7510686

Karl J. Dreher
State of Idaho
Department of Water Resources

The following is my response to item # 3 on the Notice of Error Reply

SRBA Recommendation:

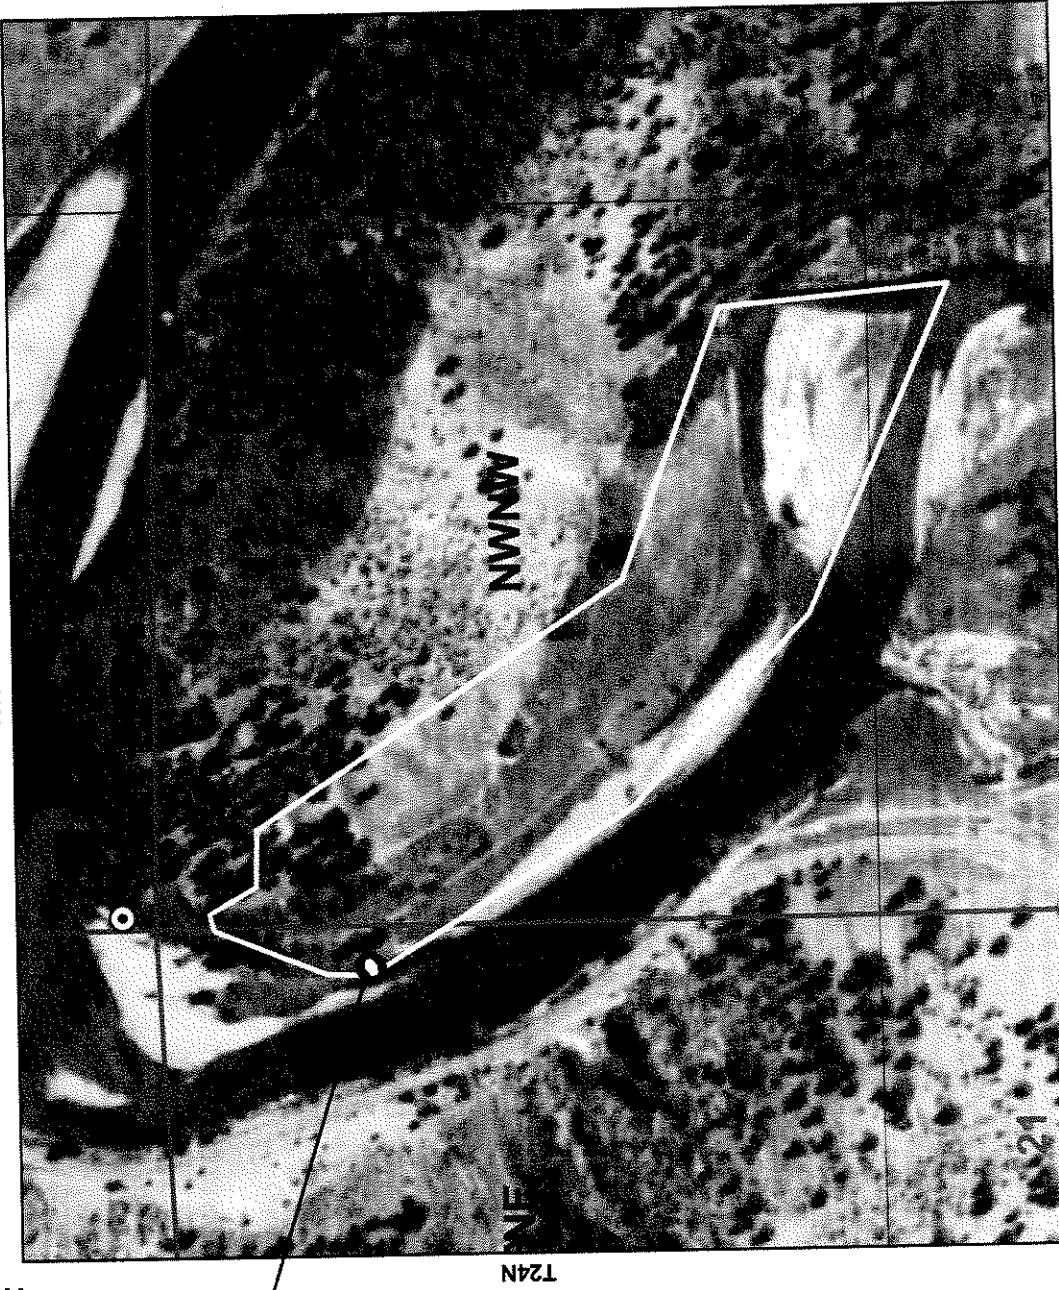
Two points of diversion were marked in the original report made in August 2006 by Jack Ellis. The secondary point of diversion shown on the map in the Preliminary Recommendation is for a ditch that would have to be reinstated. The primary point of diversion was omitted from the Preliminary Recommendation; the omitted point of diversion is an irrigation pump that is the only source relied upon at this time. In speaking with Ken Knoblock, Friday, December 1, he recommended including a map of the proposed additional point of diversion.

*PRIMARY POINT OF
DIVERSION. IN USE AT
PRESENT TIME.*
